## DEVIATION REQUEST AND DECISION FORM

Project Name :	Glen at Widefield Filings 7, 8, and 9
Schedule No.(s) :	55220-00-008
Legal Description :	The Glen at Widefield Subdivision Filing No. 7, No. 8, and No. 9

A deviation from the standards of or in Section **2.5.2.B.6** of the Engineering Criteria Manual (ECM) is requested.

TIER III 6-FT DETAIL  
NOT TO SCALE

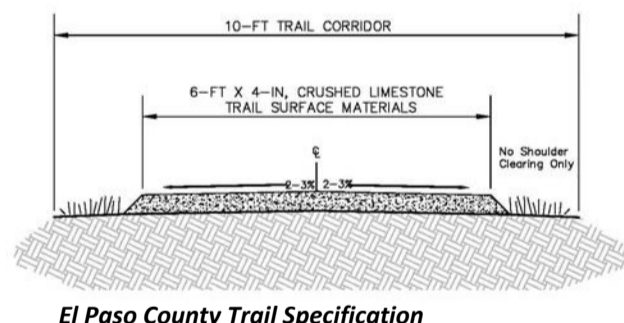
The use of concrete sidewalks on both sides of the roadway.  
The developer is requesting that a gravel sidewalk be allowed on the west side of Spring Glen Drive in conjunction with the adjacent open space trail system.

The developer proposes to install a 'trail-type path' on the west side of Spring Glen Drive that will connect and tie together the trail system within the Open Space. There are no permanent vehicular accesses along the west side of Spring Glen Drive with the exception of maintenance access for the Widefield Water and Sanitation District's lift station and the three detention basins located west of Spring Glen Drive serving the Glen at Widefield subdivisions.

A hybrid system can be entertained, as well as reducing the width by 1' (to 4') can be entertained with a soft trail adjacent to the hard trail. ADA requires this be a hard sidewalk.
